MT EDGE CUMBE HIGH SCHOOL CLASSROOM RENOVATION BUILDING 290 & 299

SITKA, ALASKA

AS-BUILTS P. 67551-1
BEGIN DATE: 6-2-04
END DATE: 8-27-04
D. Newell project engineer

STATE OF ALASKA
 DEPARTMENT OF TRANSPORTATION & PUBLIC FACILITIES
 STATEWIDE DESIGN & ENGINEERING SERVICES DIVISION
 MT EDGECUMBE
 HIGH SCHOOL
 CLASSROOM
 RENOVATION

1 1ST FLOOR DEMOLITION PLAN - BUILDING 290

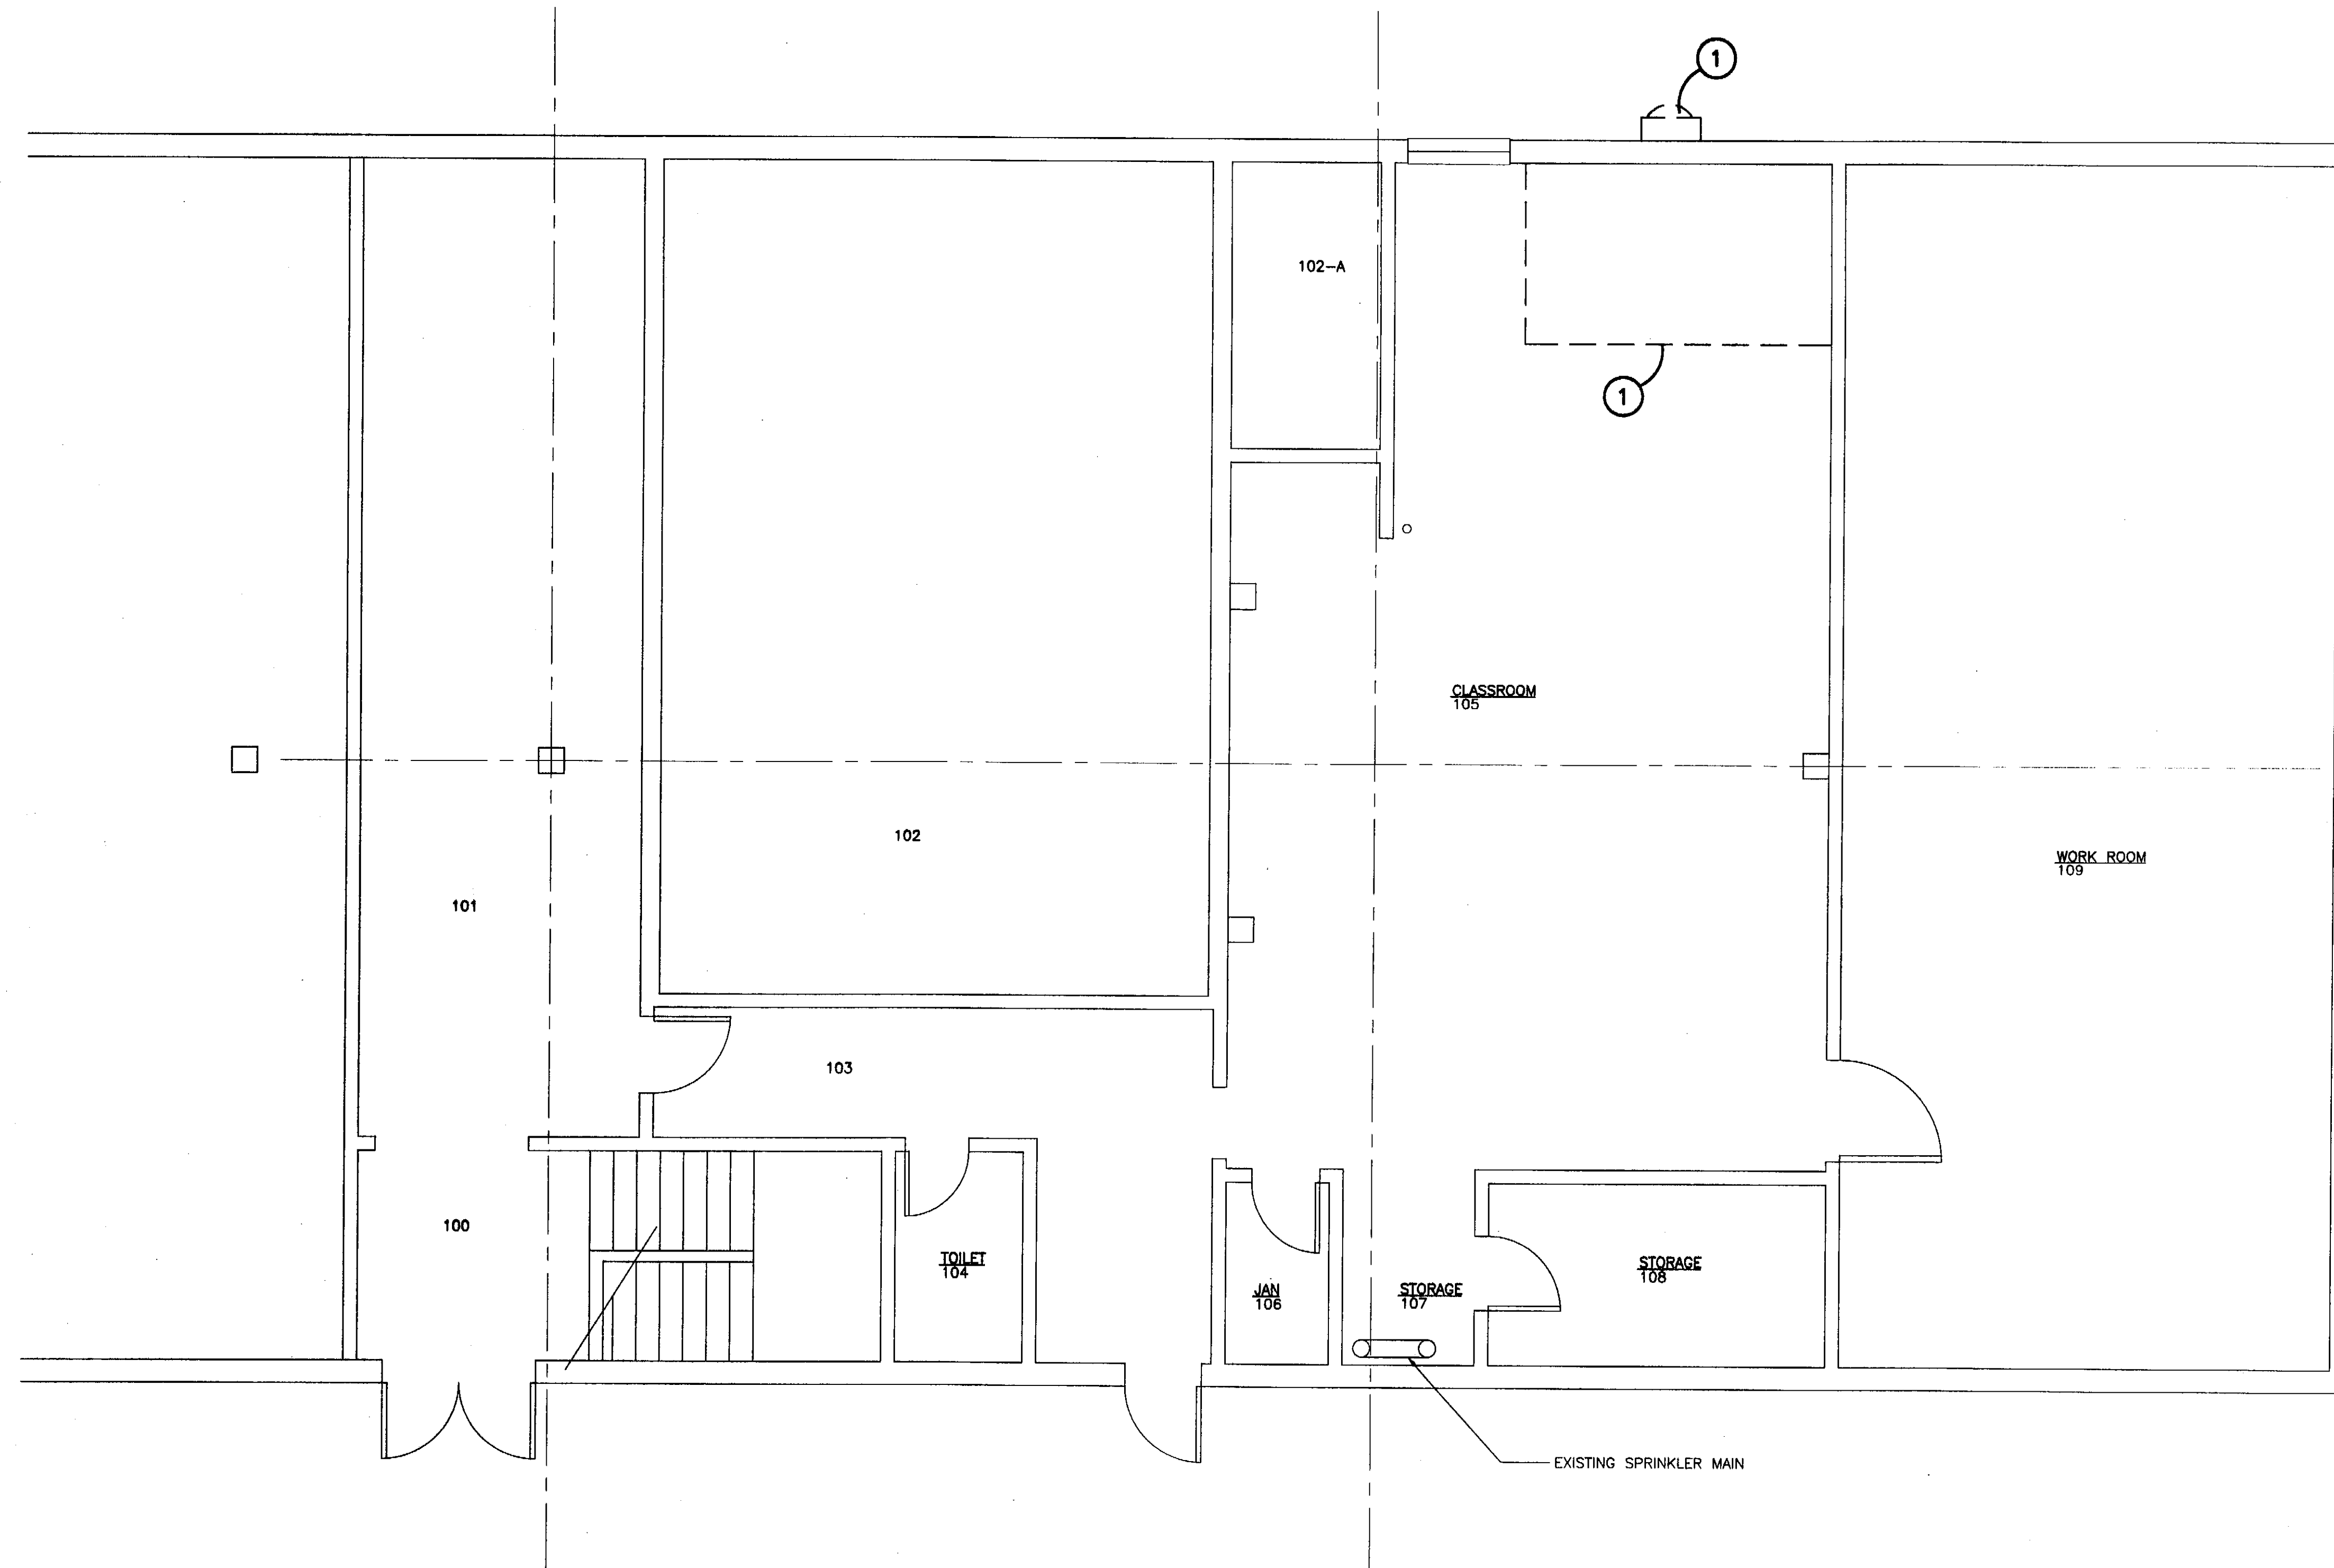
8 Removing Existing 1/4 drain
COW 6

1 2ND FLOOR PLAN - BUILDING 290
SCALE: 0 2' 4' 8'

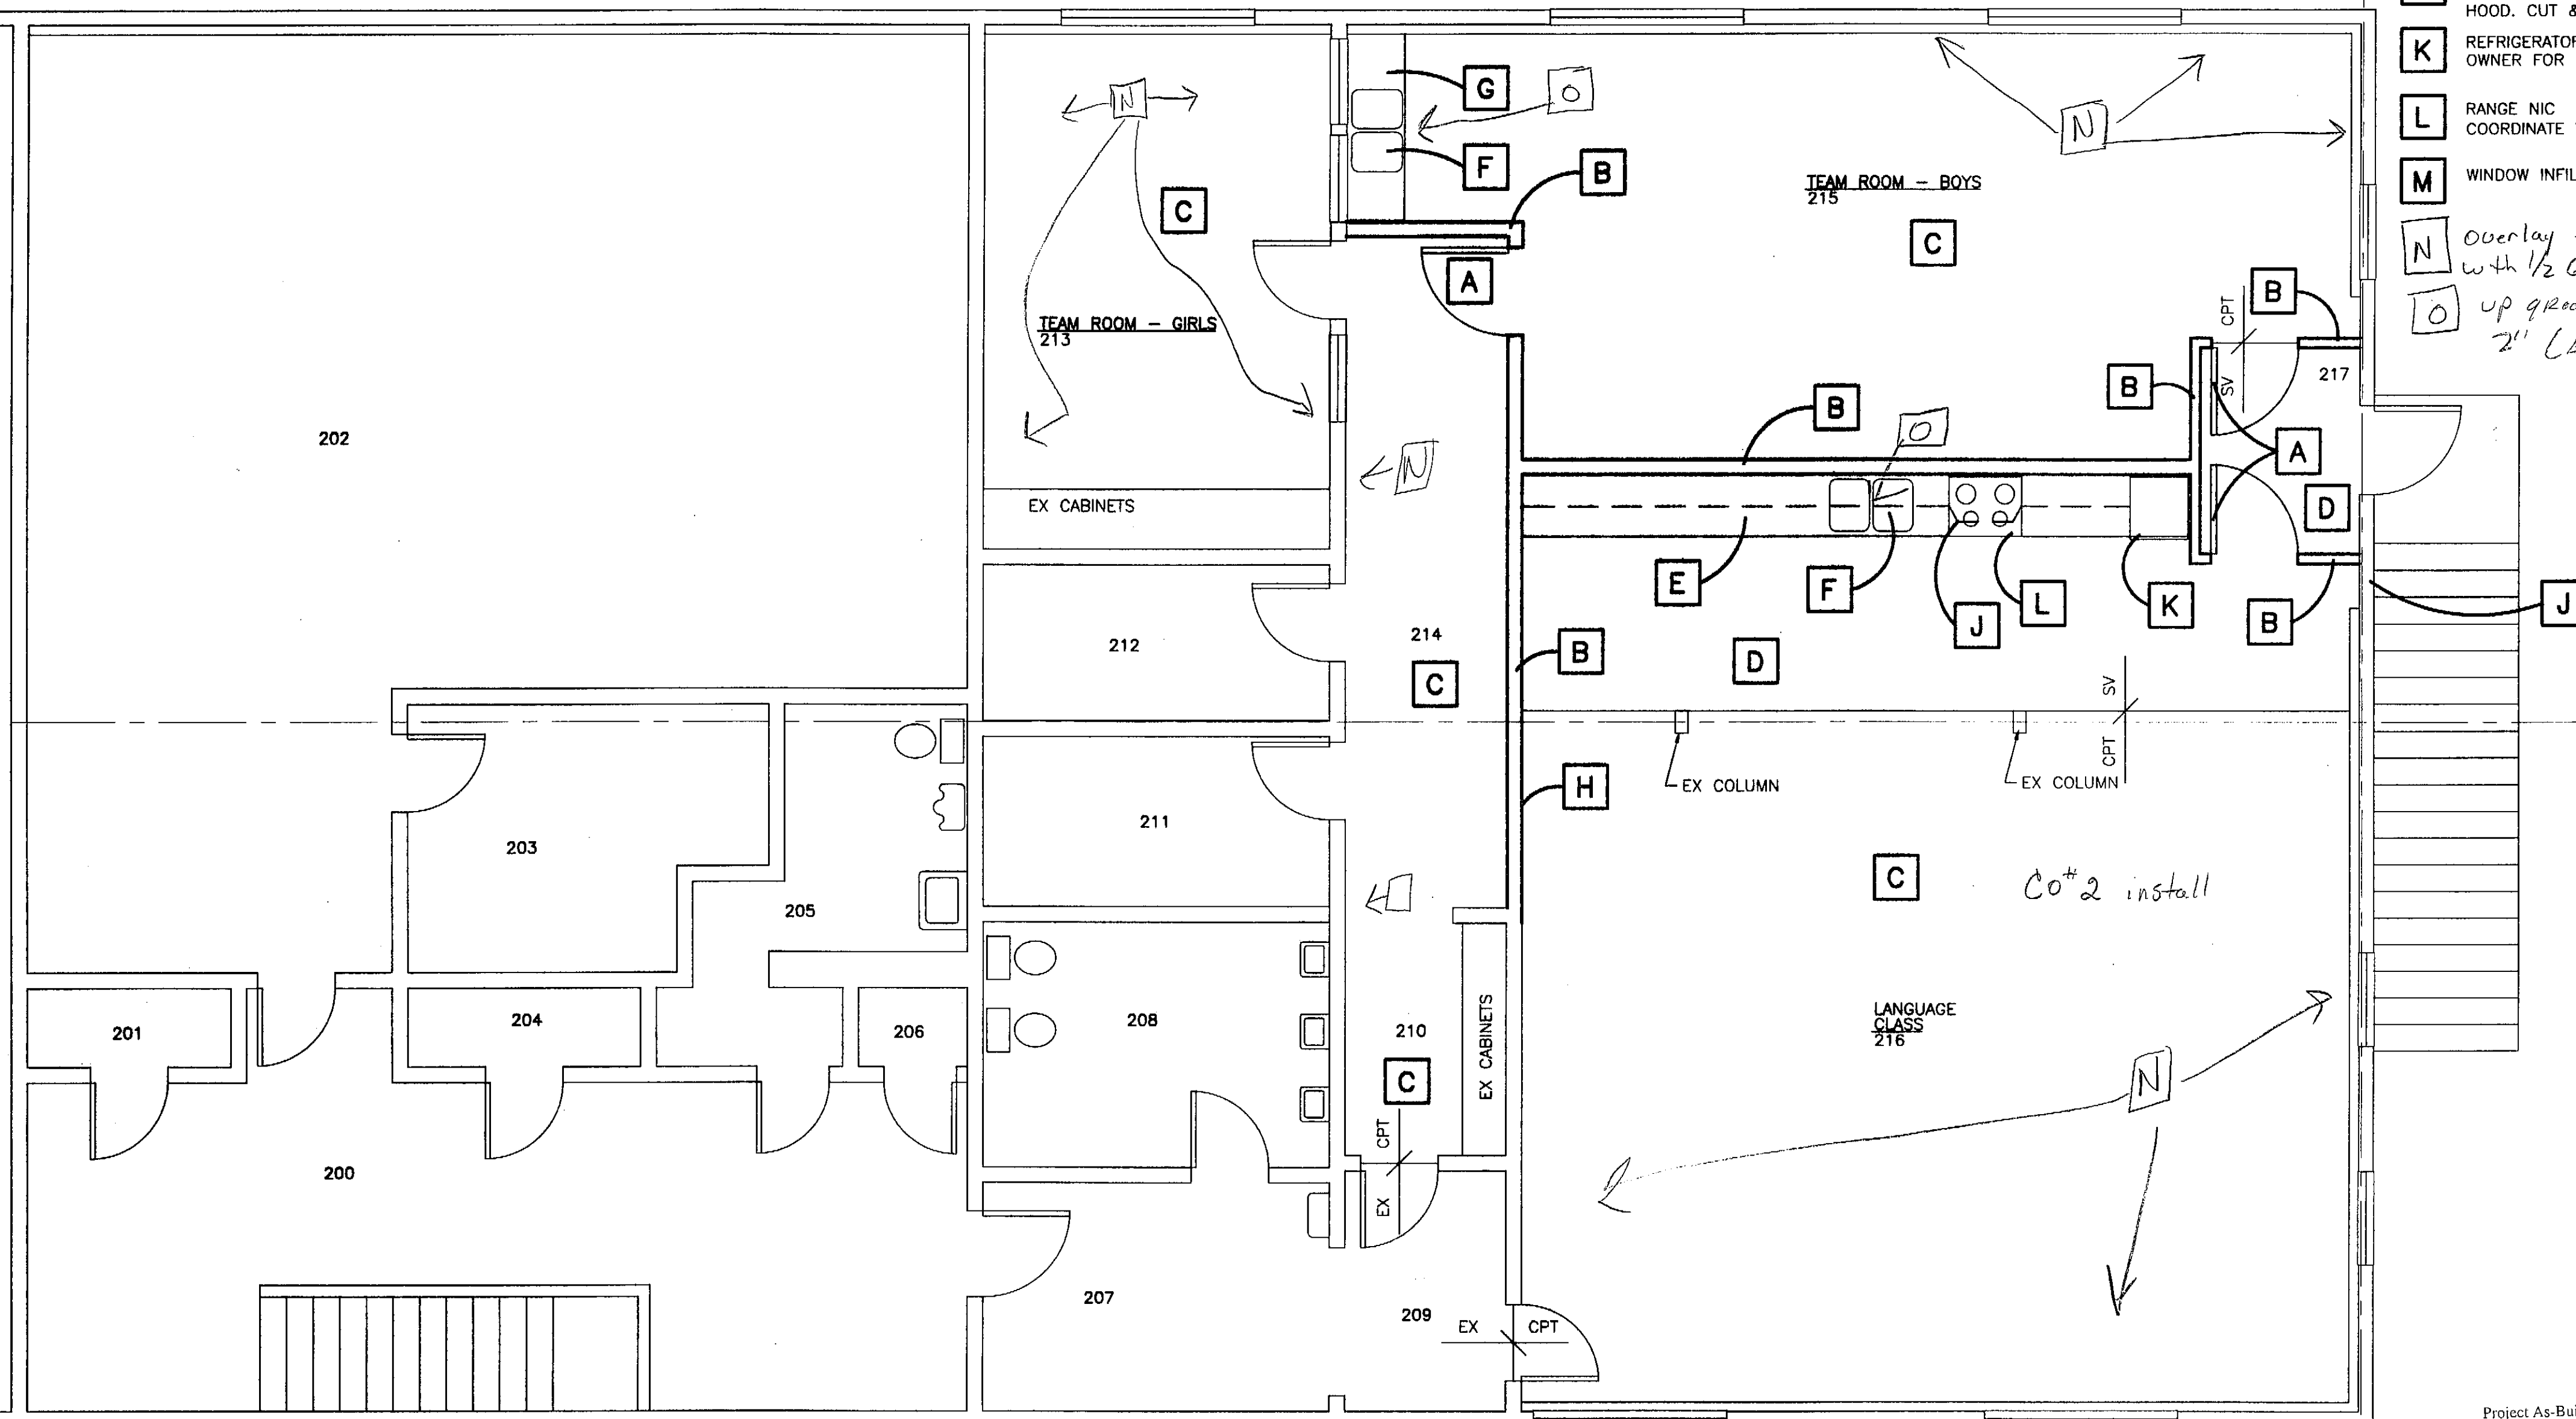
- M WINDOW INFILL SEE 3/A202
- N Overlay existing walls with 1/2 GWB. (Co#2) up grade existing drain to 2" (Existing 1 1/4").

1 2ND FLOOR PLAN - BUILDING 299

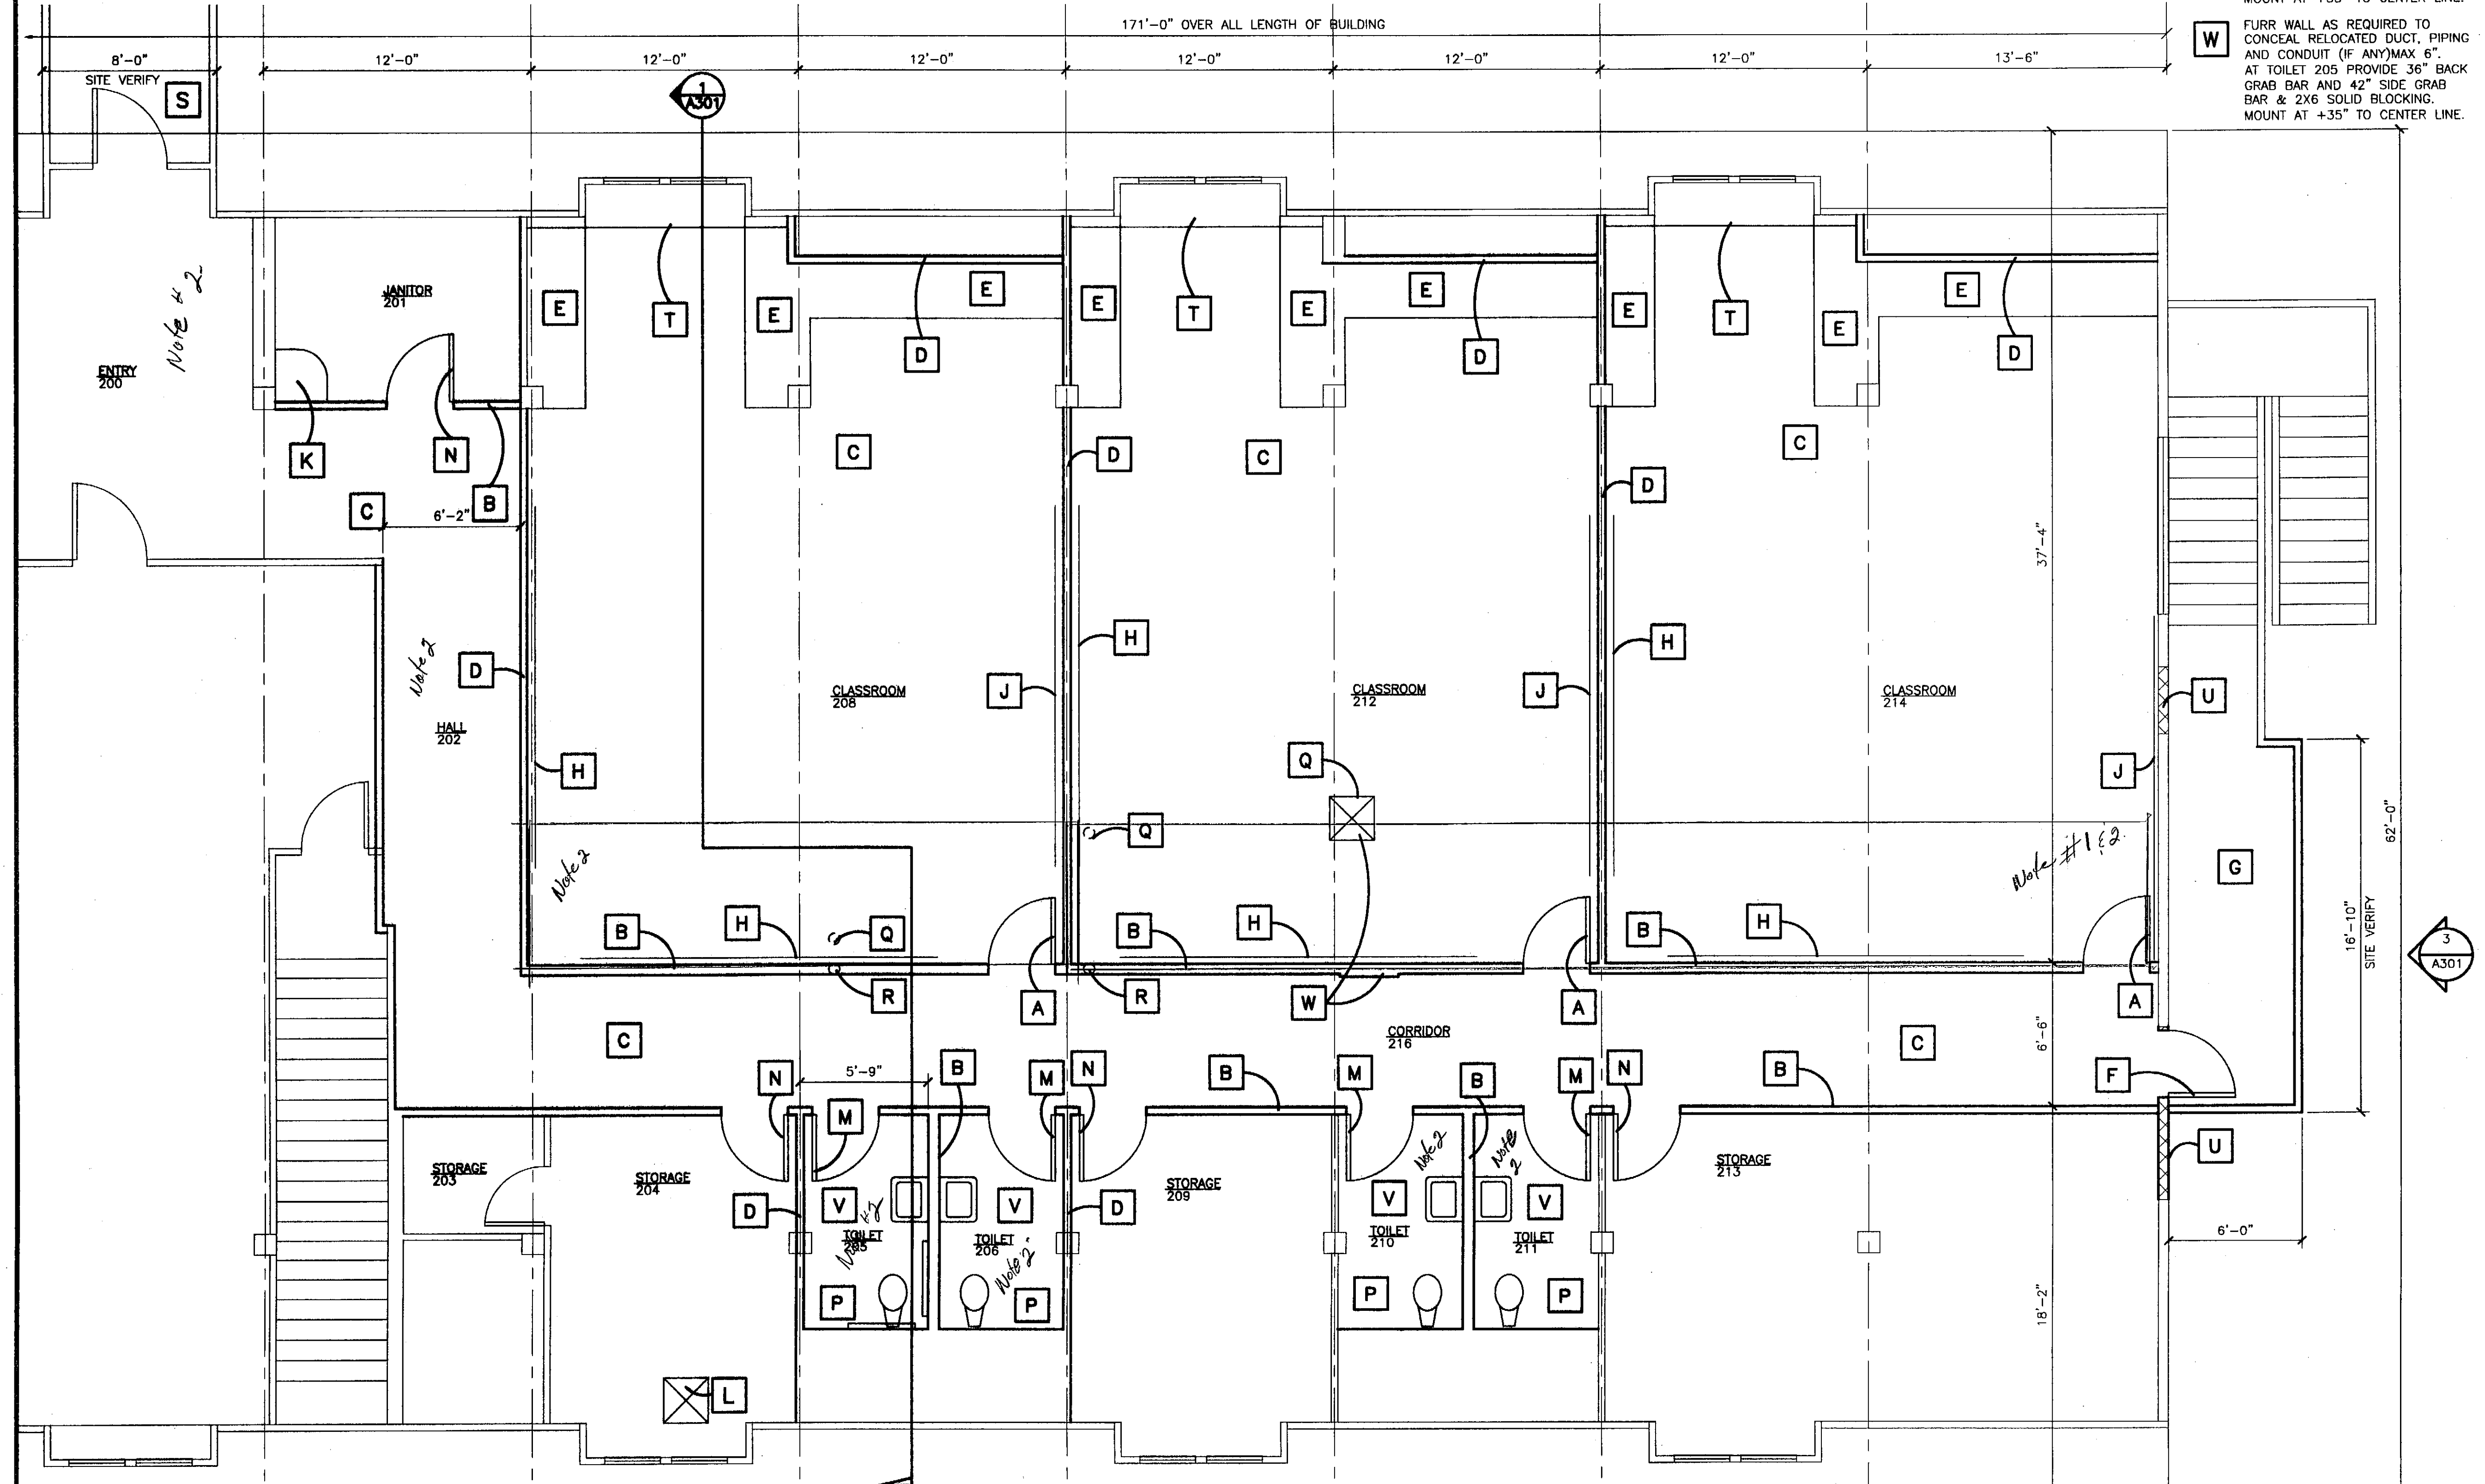
1 Extend existing Plaster Ceiling to New Corridor wall, Insulate with Batt

2 Install underlayment over existing Rubberize tile. (Contact is eliminate all floor height transitions)
